**LEUPA**

**Container for low-enriched uranium**

**INDEPENDENT REVIEW OF DOCUMENT  
0908-LE01-3BEIN-024-B: LEUPA -  
CRITICALITY ANALYSIS**

Document NO.: 0908-LE02-3BEIN-007 Revision: A			
		Document Title: INDEPENDENT REVIEW OF DOCUMENT 0908-LE01-3BEIN-024-B: LEUPA - CRITICALITY ANALYSIS			
REVISION SHEET		Ref. NO.:			
		Write name, date and sign			
Revision Letter	Description of the Revision	Prepared by	Revised by	Approved by	
A	Original	FA	NG	JCO

Figure 4: Hexagonal arrangement of packages in a circular container.

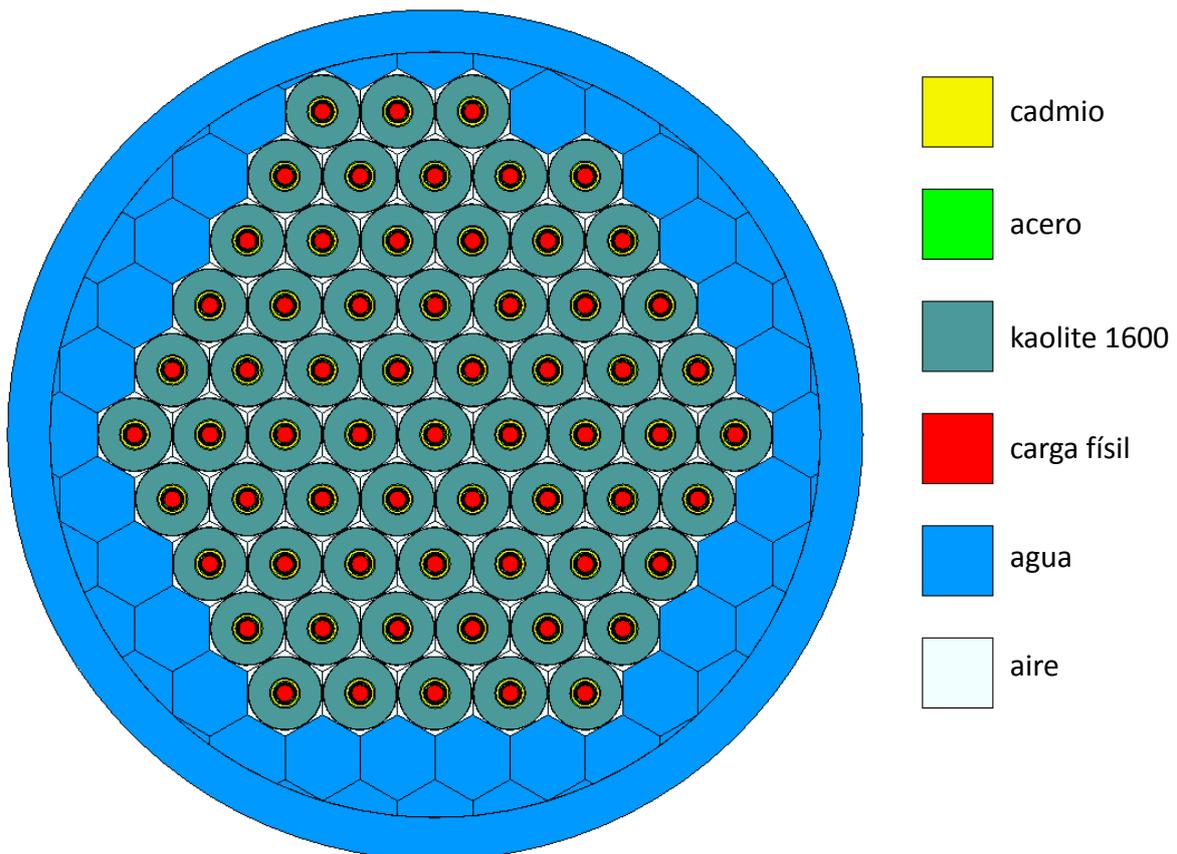
- The effect of inverting the package is therefore reduced. The modeled case is useful to prove the subcriticality of the packages disposition, regardless of the vertical position of the packages.
- To evaluate the effect of assuming a different geometric arrangement of packages, a case in which packages are distributed in an hexagonal arrangement was simulated (Figure 4), keeping the same 6 axial levels assumed on the square disposition. The result is as follows:

Figure 5: Variation of the effective multiplication factor based on the mass of water retained in the Kaolite 1600

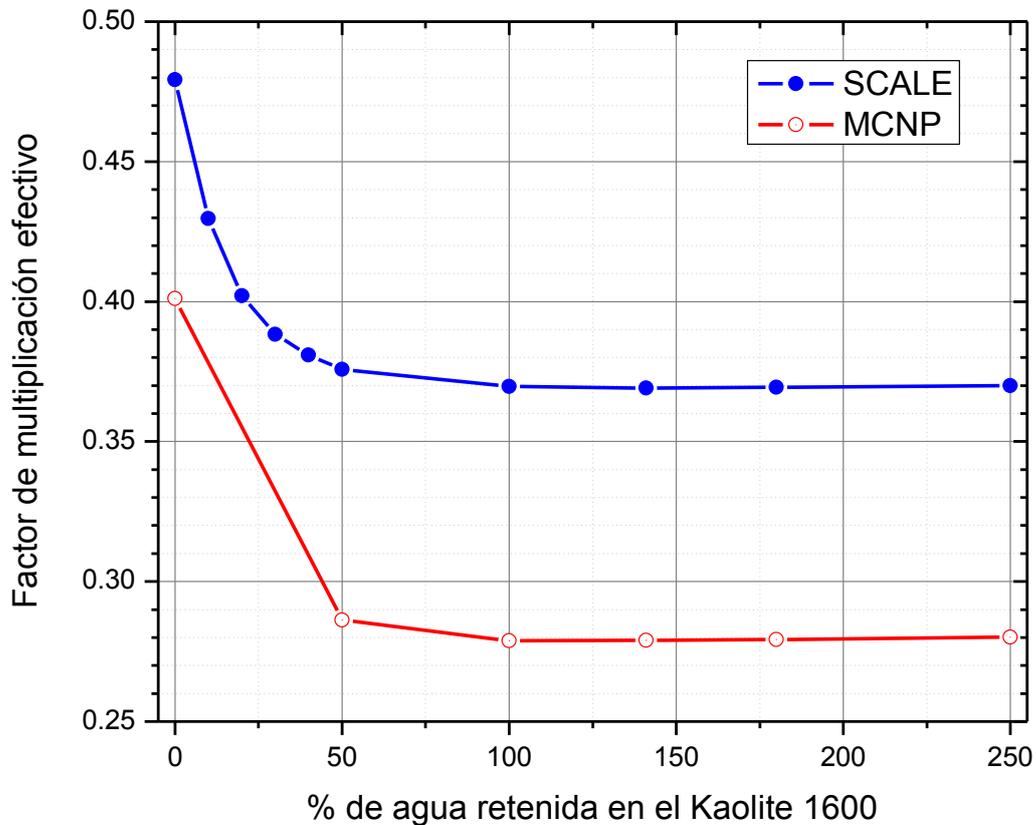
4. Figure 5 contains a graph on the values of ( $k_{ef} + 3\sigma$ ) obtained with MCNP and SCALE, based on the percentage of water retained by the insulation.
5. The SCALE calculation confirms that the most unfavorable situation from the criticality standpoint is the case of dry heat insulation, as stated in [2].

Figure 6: Variation of the effective multiplication factor based on the density of water entering the empty spaces inside and outside the package

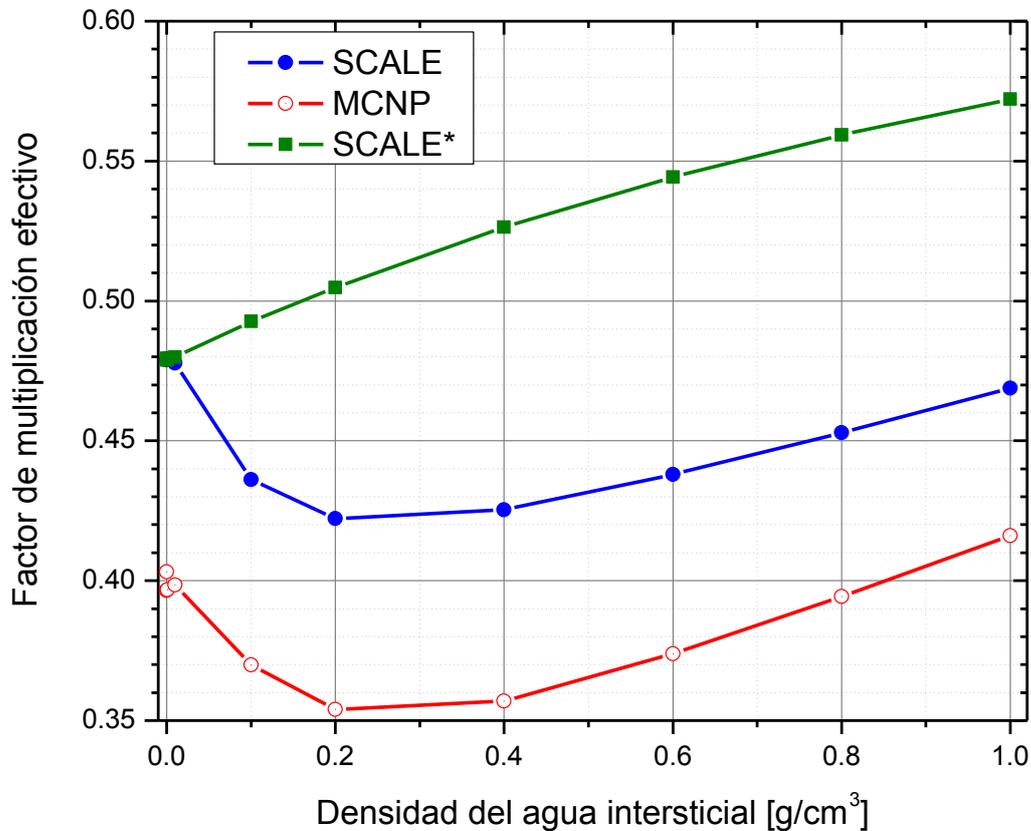
5. Figure 6 shows the values calculated with MCNP (red curve, empty circles) and SCALE (blue curve, solid circles). The existence of a minimum based on the density of the water

entering the package suggests the presence of phenomena competing among them in relation to the reactivity of the system. In order to identify and separate these phenomena, another series of calculations was prepared, where the inflow of water to the package was simulated, but only to empty spaces located within the confinement system. In other words, we simulate a scenario where there is water inflow only through empty spaces located on the inside of the cadmium cover. The results obtained are shown in the last 3 columns of Table 3, under the heading "SCALE\* (H<sub>2</sub>O confinement only)".

- The curve indicated as "SCALE\*" (green curve) in Figure 6 shows that the more reactive case is that where the water inflow only to the existing empty spaces inside the cadmium cover is simulated. This water provides moderation to the sub-moderate system and therefore the multiplication factor increases with the inflow of water.
- On the contrary, when water is also added outside the cadmium cover, the additional moderation obtained does not translate into an increase of the effective multiplication factor of the system, since the thermalized neutrons in the area outside the cadmium cover are absorbed in the cadmium before re-entering the containers with fissile material.

Figure 7: Variation of the effective multiplication factor based on the mass of water entering each internal container

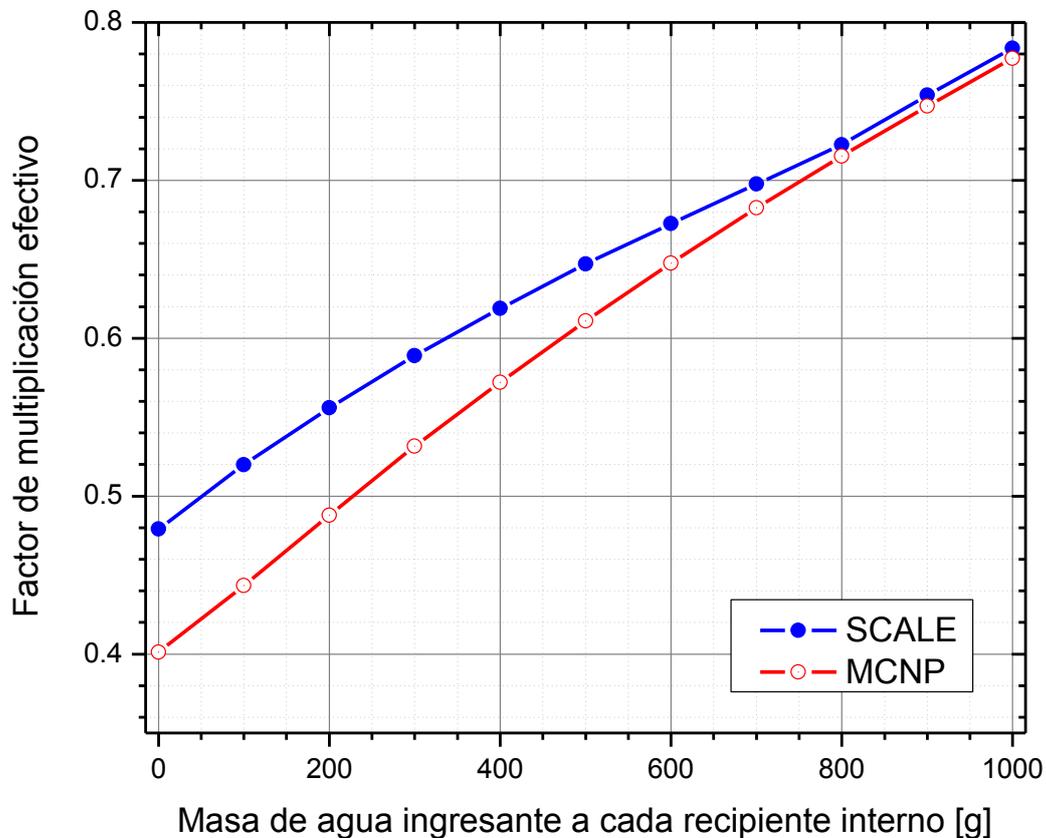
6. **Figure 7** contains the calculated values.
7. We can see that the multiplication factor increases monotonously with the water mass entering the inside container. Be it reminded that, given the measurements of the internal containers and the nominal mass of uranium metal per container, it is not possible to add more than 900 g of water per internal container.
8. In all cases, the value calculated with SCALE is higher than the value calculated with MCNP. The difference between both calculations is reduced to a minimum as the mixture of water+uranium metal modeled in SCALE fills the free volume of each interior container, since the differences in the fissile volume modeled with both codes is reduced when water is added to the container. This behavior confirms what is stated in section 7.4.1, paragraphs 3 to 6.

Figure 8: Variation of the effective multiplication factor depending on the density of water entering the gaps in the packages arrangement, when the insulation is dry

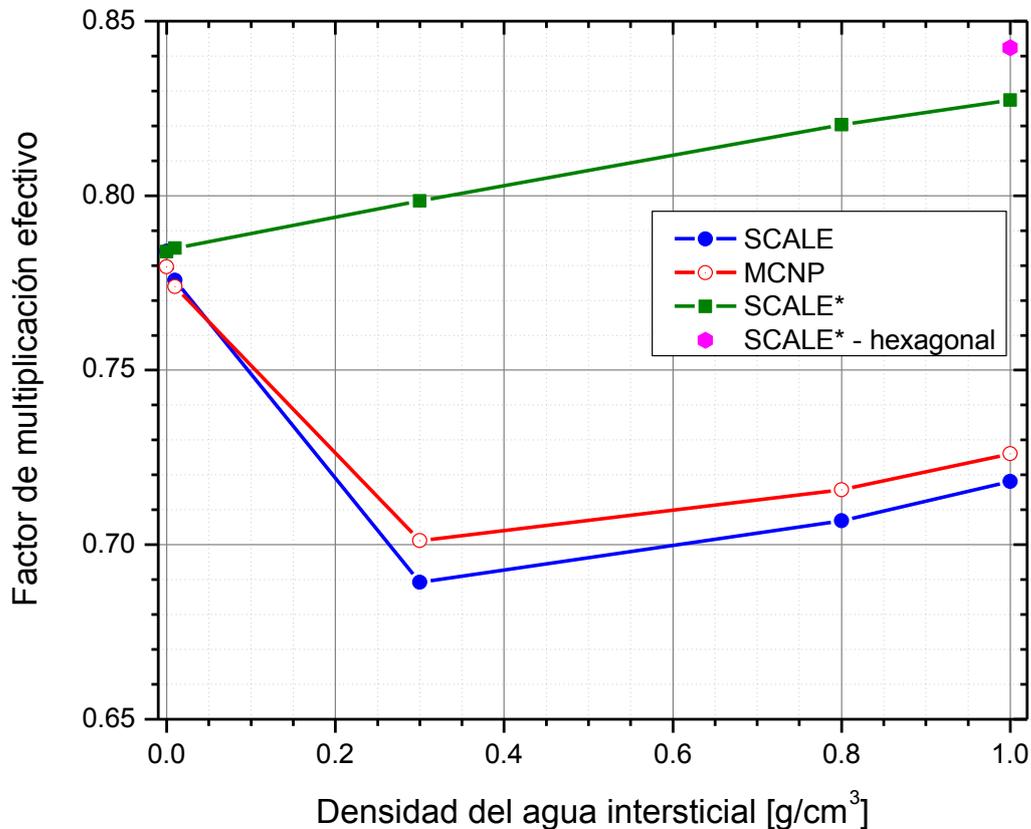
11. It is precisely in this group of cases calculated with SCALE where the more reactive case is identified: internal containers flooded with water (1000 g water per container), dry thermal insulation, and maximum density of water in empty spaces located inside the confinement.

12. Cases resulting in the maximum  $k_{\text{eff}}$  obtained with MCNP and SCALE are highlighted in **Table 5**.
13. **Figure 8** contains a graph of the results obtained with MCNP and SCALE, for cases where the insulation is dry, for different densities of water entering the gaps (homogeneous inflow of water in all the gaps of packages, and inflow of water only to the gaps located to the interior of the confinement, indicated with the label "SCALE \*" in **Figure 8**).

14. In all those cases, a square arrangement of packages was simulated in the system. Figure 8 also shows a calculation point that corresponds to the simulation of an hexagonal arrangement of packages in the system ( $k_{\text{eff}}+3\sigma = 0.84234$ ).

Figure 9: Multiplication factor depending on the density of the interstitial water, for different cases in which cadmium did not infiltrate into the cadmium chamber

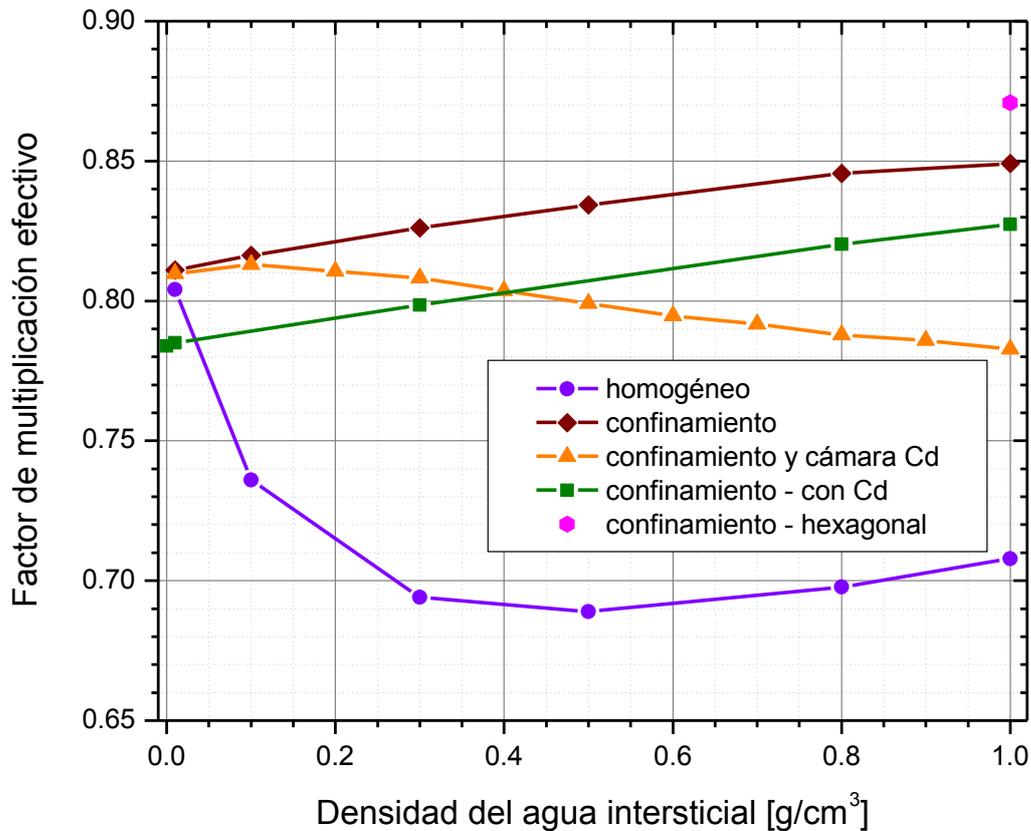
9. The curve displayed in Figure 8 is repeated in Figure 9 when water enters only the interior of the confinement (curve labeled as "confinement - with Cd"), for the sole purpose of making the effect of removing the cadmium from the cadmium cover visible.

10. In all those cases, a square arrangement of packages was simulated in the system. Figure 9 also shows a calculation point that corresponds to the simulation of an hexagonal arrangement of packages in the system ( $k_{ef}+3\sigma = 0.87083$ ).

11. It can be seen that, again, the worst case is the one in which internal containers are flooded with water (1000 g of water), the insulation is dry, water enters only into the gaps within the confinement, and the density of water in these empty spaces is equal to  $1 \text{ g/cm}^3$ . This case, which yielded the highest effective multiplication factor of all those evaluated so far, shows that even under the hypothesis of this accidental case, the subcriticality of the packages system is assured with one sufficient margin.
